MAC THOMPSON SITE PLAN

SP# 12-21

STAFF REPORT #2

PLAN UNDER REVIEW: Tax Map 190 Lot 191, MacThompson Site Plan, 48 Lowell Road, Hudson, New Hampshire 03051; prepared by Benchmark LLC, 1F Commons Drive, Suite 35, Londonderry, New Hampshire 03053; prepared for owner MacThompson Realty, Inc., 3 Marmon Drive, Nashua, New Hampshire 03060; consisting of 11 sheets with General Notes 1-32 on Sheet 3; dated August 3, 2021, and last revised on November 15, 2021.

COVER PLAN
TAX MAP 190 LOT 191
MACTHOMPSON SITE PLAN
48 LOWELL ROAD
HUDSON, NEW HAMPSHIRE 03051

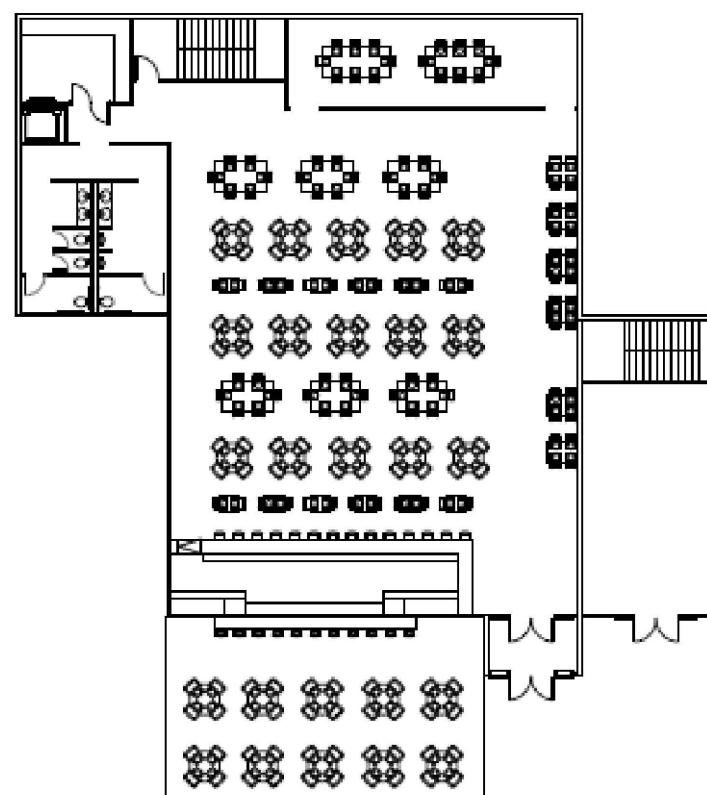
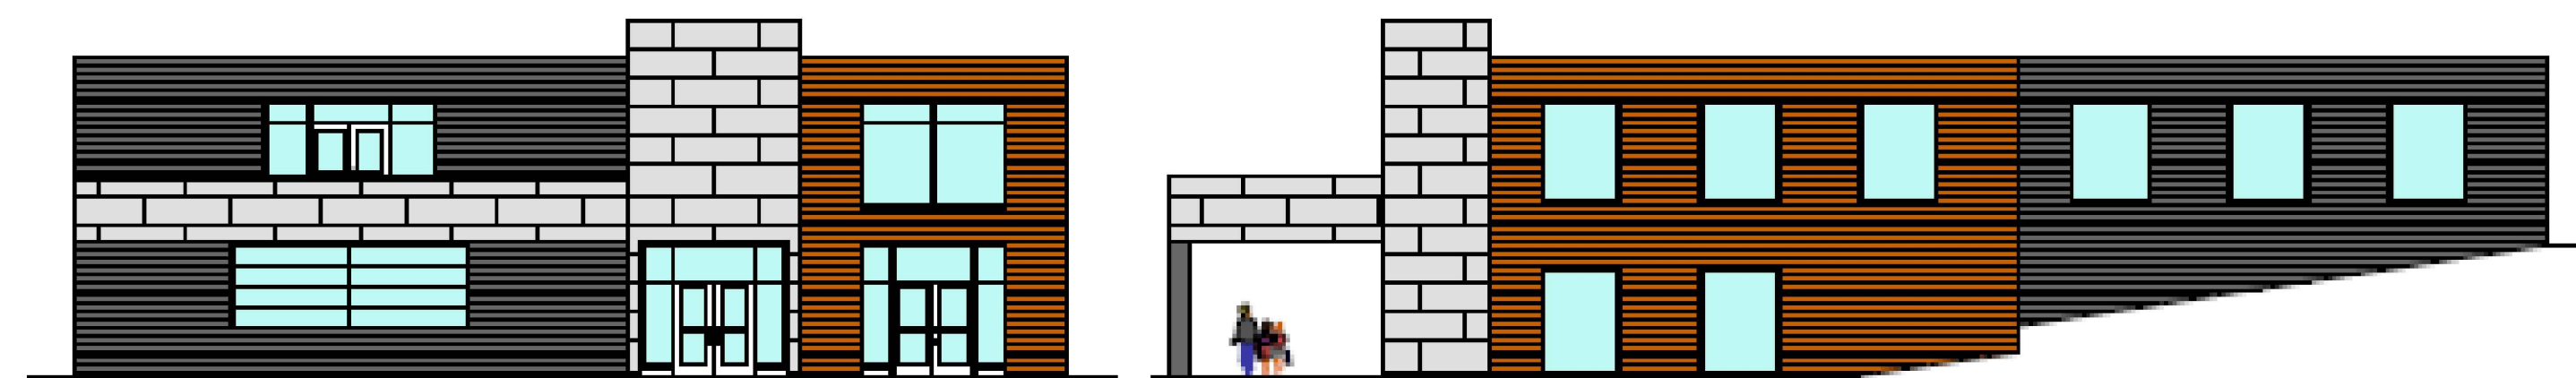
2. Building Details on the Site Plan: The sectional views of the building façade and restaurant floor plan on Sheet 1 (Cover Plan) appear to show a semi-basement and an overhang structure. Both the sections and floor plan appear to be inconsistent with the building footprint on the Site Plan. The Applicant should verify the building design and illustrate these building details on the Site Plan.

The conceptual building architectural's is now shown on the cover plan.

SCALE: 1"=30' SHEET 3 OF 11 AUGUST 3, 2021

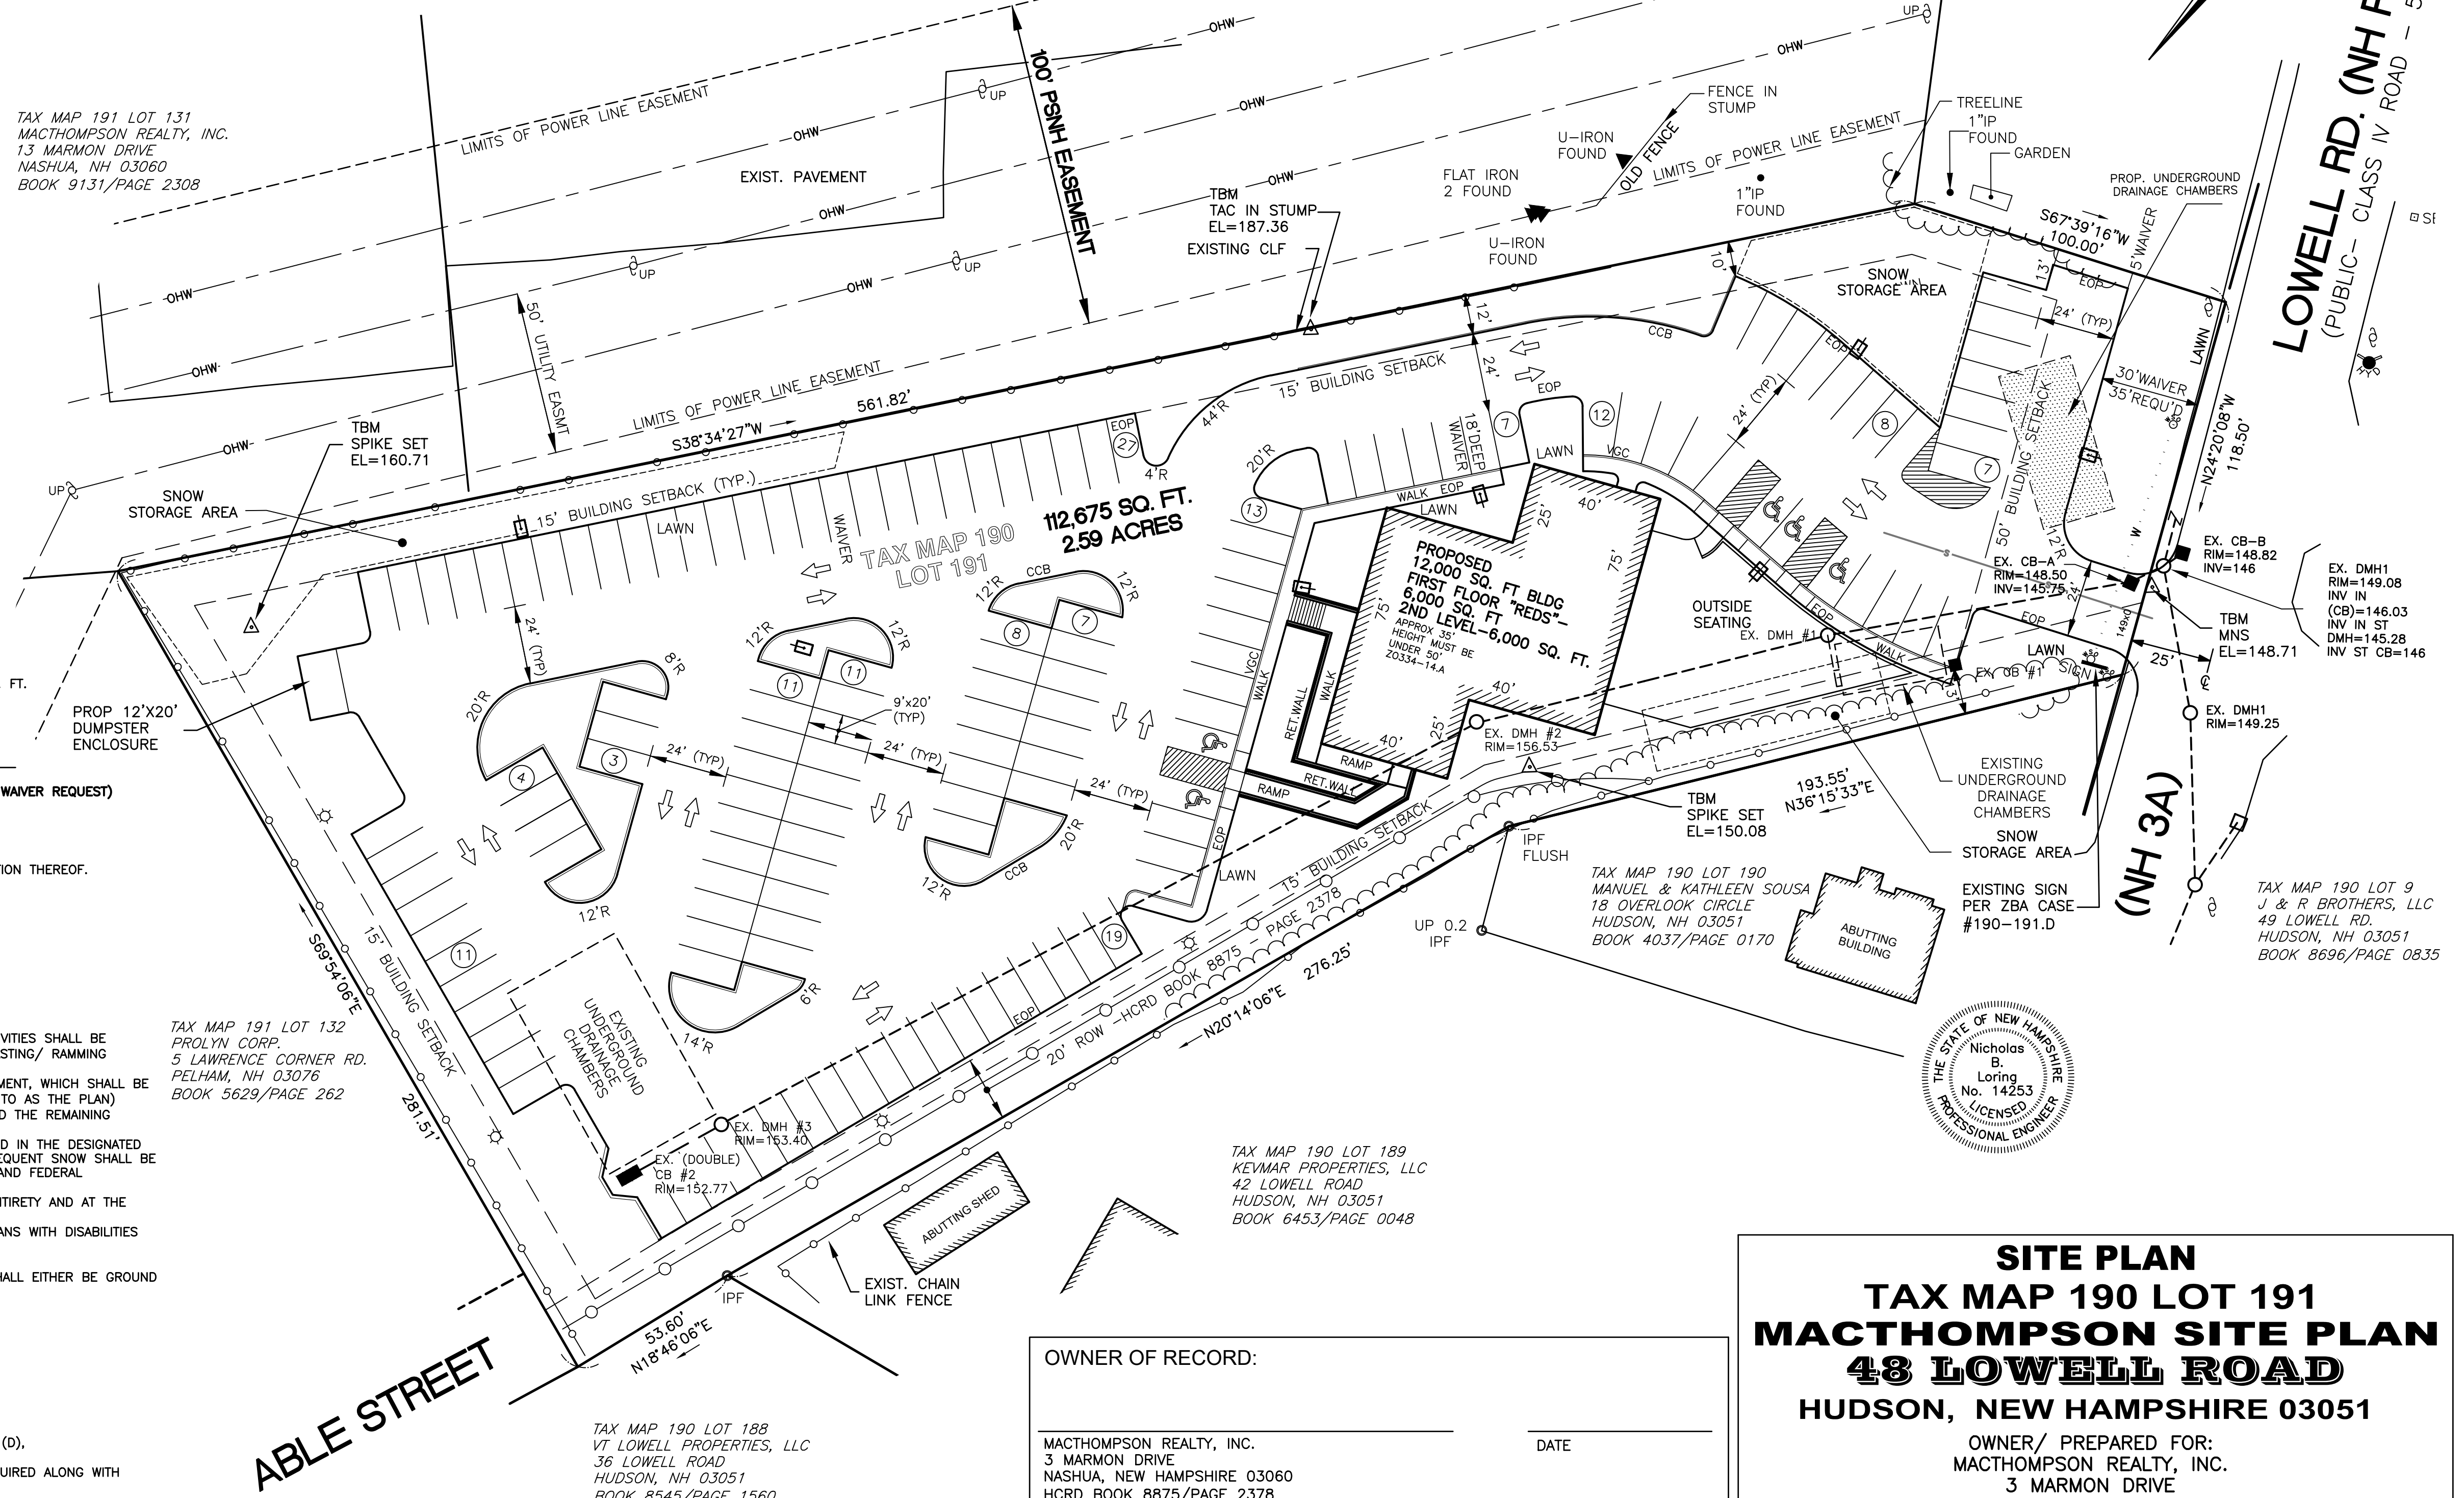
- a. Parking Calculations [§ 275-8.C(2)]:** **Parking Calculations [§ 275-8.C(2)]:** The parking calculation in the revised plan (Note #14 on Sheet 3) appears incorrect. The first line of the calculation is a requirement and should not be counted.

The Applicant's parking calculation using the size of the kitchen staff (on the fourth line), while reasonable in determining the parking requirement for the kitchen portion of the restaurant, is inconsistent with the regulations and require a waiver. The Applicant may amend the submitted waiver request for § 275-8.C(2) to include this element but should clarify whether 5 employees per kitchen represents the largest shift, which will be a reasonable number to determine the parking spaces required.

The Applicant should revise General Note 17 on Sheet 3 to:

- p. Note 31, sheet 3 was added to show that the maintenance of the stormwater system is the responsibility of the property owner.
- q. The drainage manhole detail is on sheet 9. Many of the manholes are existing from the previously approved site plan from 2017. There are 3 new manholes (DMH#3, DMH#4, DMH#5) these are proposed to "divert" the existing drain line around the proposed building. As to the structures having no "sump" that is typical of drainage manholes as they are primarily utilized at angles in a pipe run. If there is some requirement in the Site Plan regulations for a sump in these Drainage Manholes please let us know and we will modify the plan accordingly.

SCALE: 1"=30' SHEET 5 OF 11 AUGUST 3, 2021

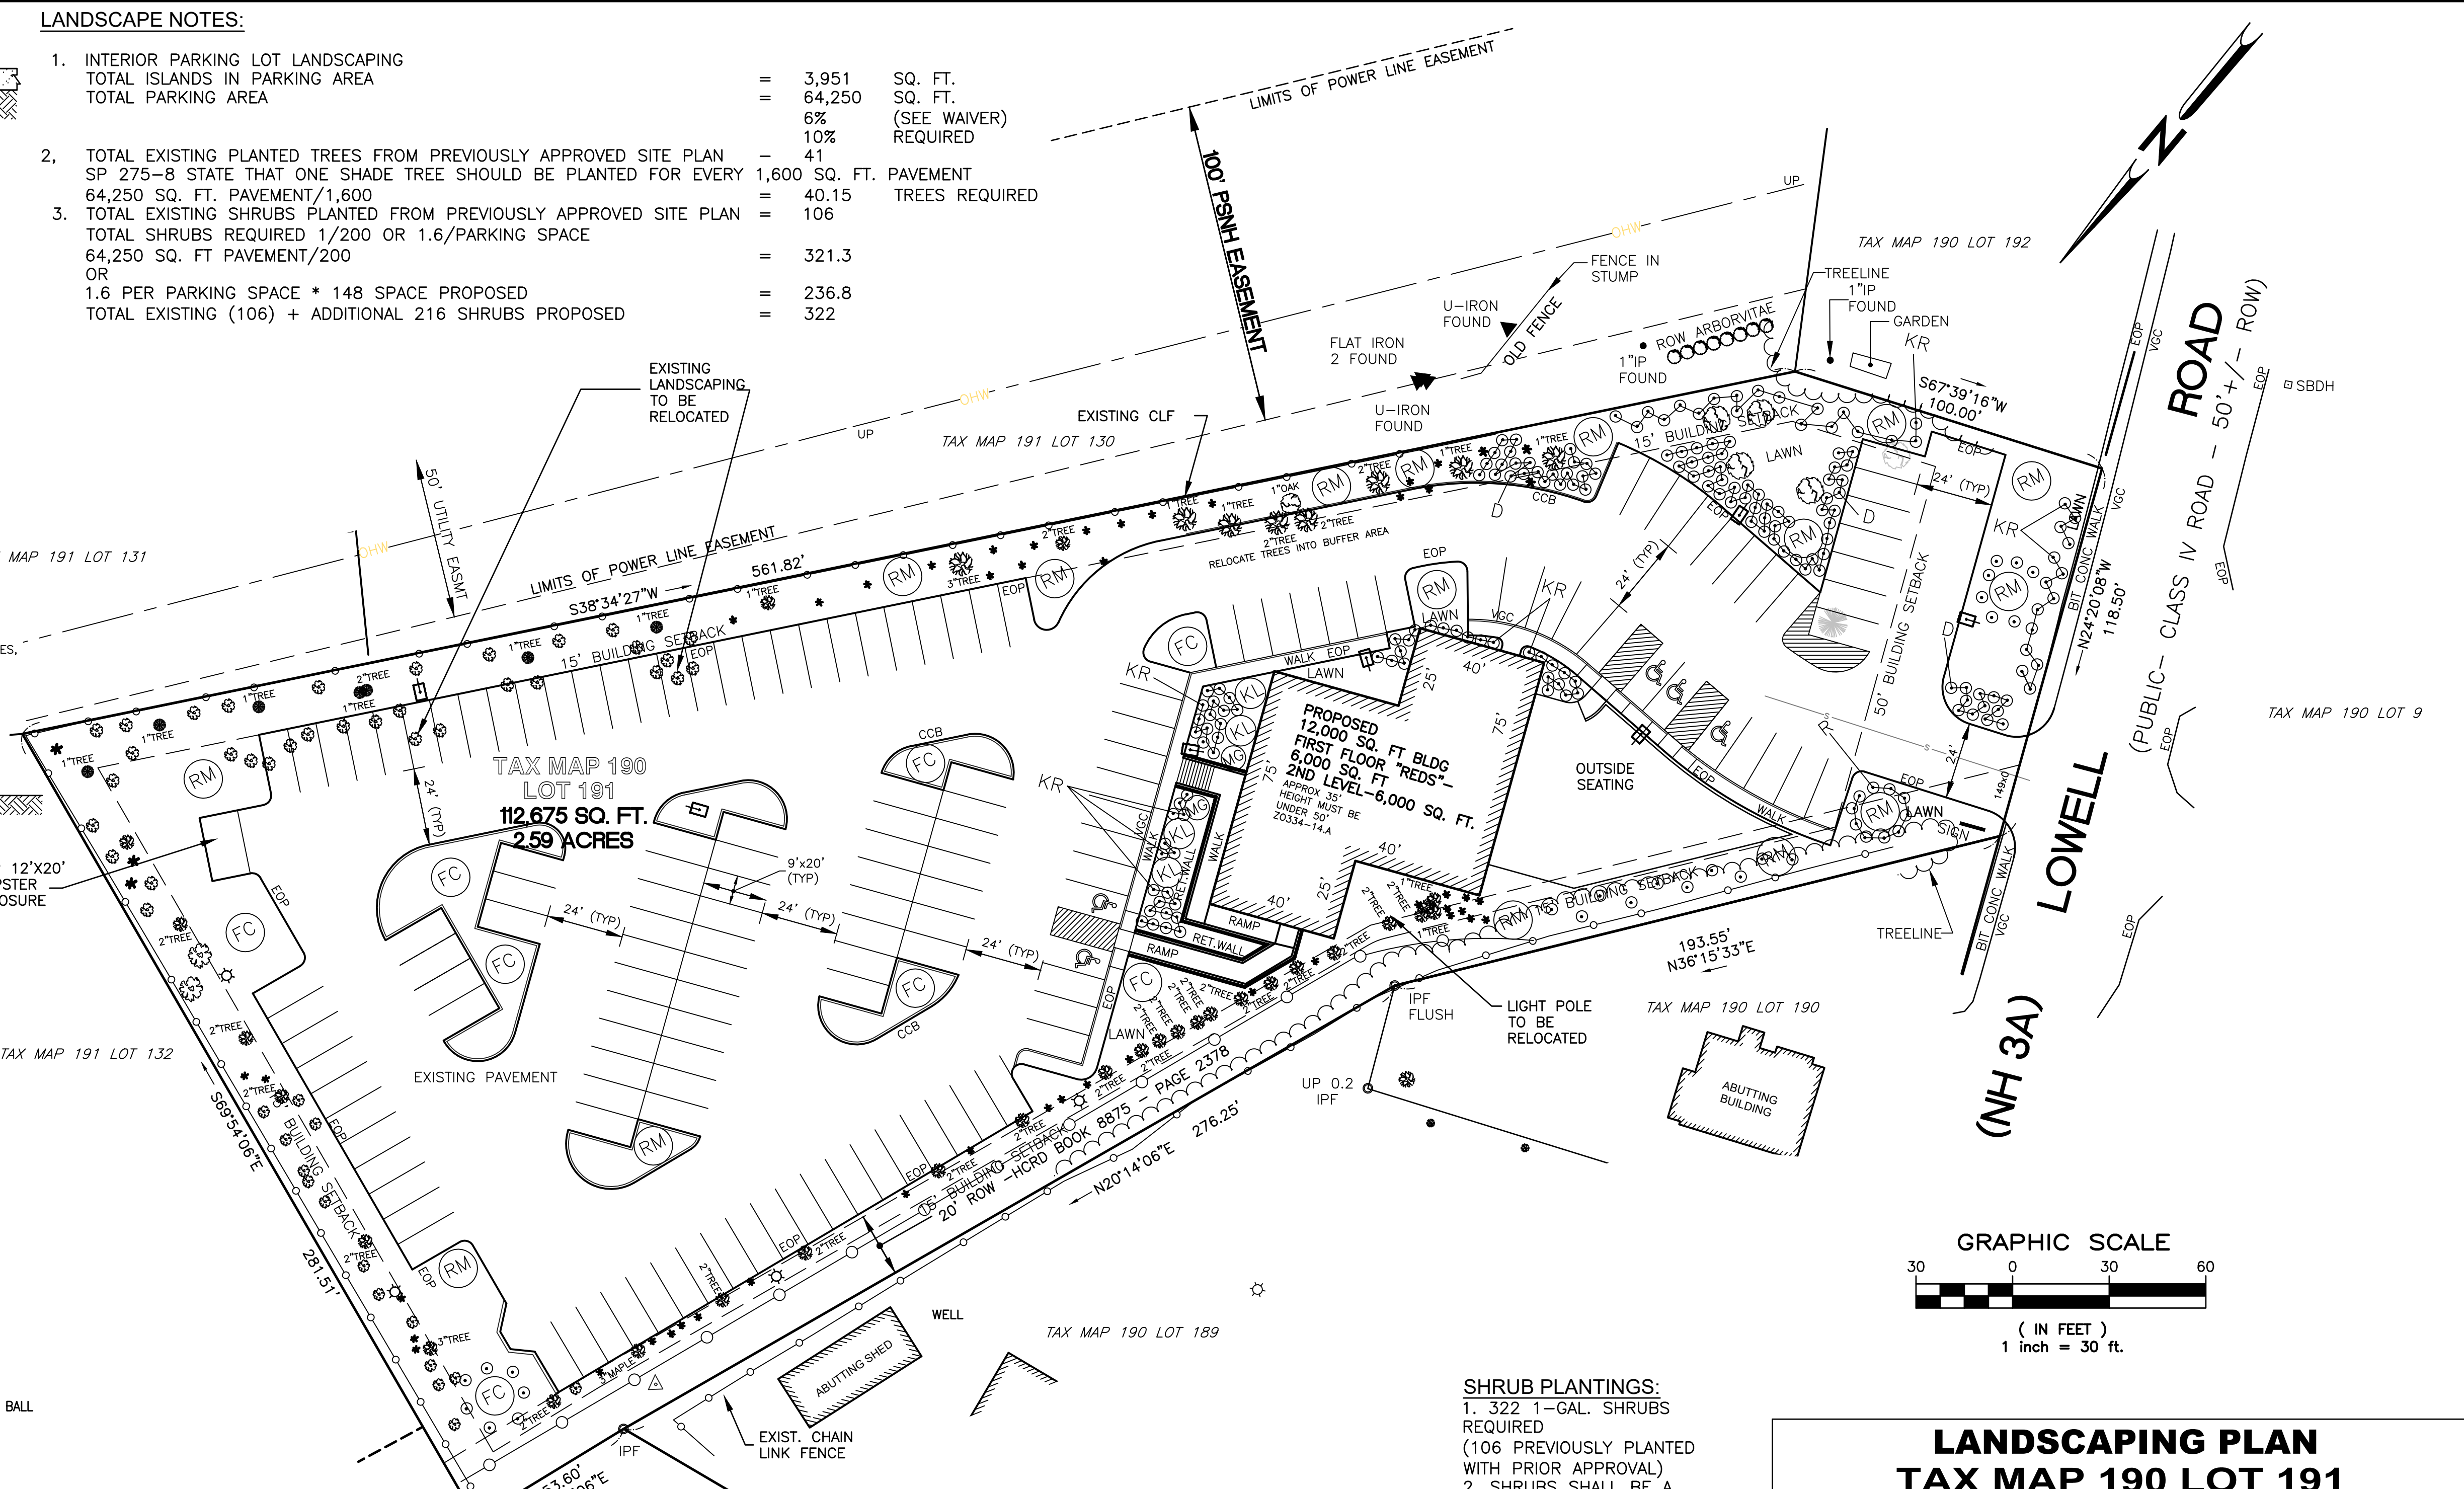
The Applicant had indicated that, despite not meeting the landscaping area requirement, the required planting will be met. Sheet 5 of the revised plan shows the

calculation of the required planting. Several outstanding issues or discrepancies with the landscape plan remain:

1. Landscape Note #2 states 41 trees were planted as part of previously approved site plan, while Shade Trees Note #1 states 36 were planted.
2. Many existing trees are identified as “to be relocated” but the plan does not identify their new location.
3. There appears to be maybe 100 1”-3” trees which are unidentified, and their canopies appear to be 3 feet wide or less, whereas the labelled trees have canopies of about 12 feet.
4. Staff has noted that in other site plans, the shrub requirement might be achieved on a drawing, but practical application is not always possible as the shrubs are too crowded. The Applicant may want to confirm that their landscape plan is achievable to prevent the need for a site plan amendment in the future.

The landscape plan should be reviewed and possibly revised to address these observations.

- a. We have added the calculation for this to the plan set (sheet 5)
- b. We had the field crew locate the existing trees on the property. There were 41 planted as part of the original approval. The calculation for the total number of trees was added to sheet 5.
- d. Similar to b above we have added additional information along with the location of existing shrubs on the property. A calculation is also included in the notes on this sheet
- e. Landscaping is on its own sheet and a legend is also included.
- f. No action necessary for the comment on lighting
- g. No action necessary on this comment.
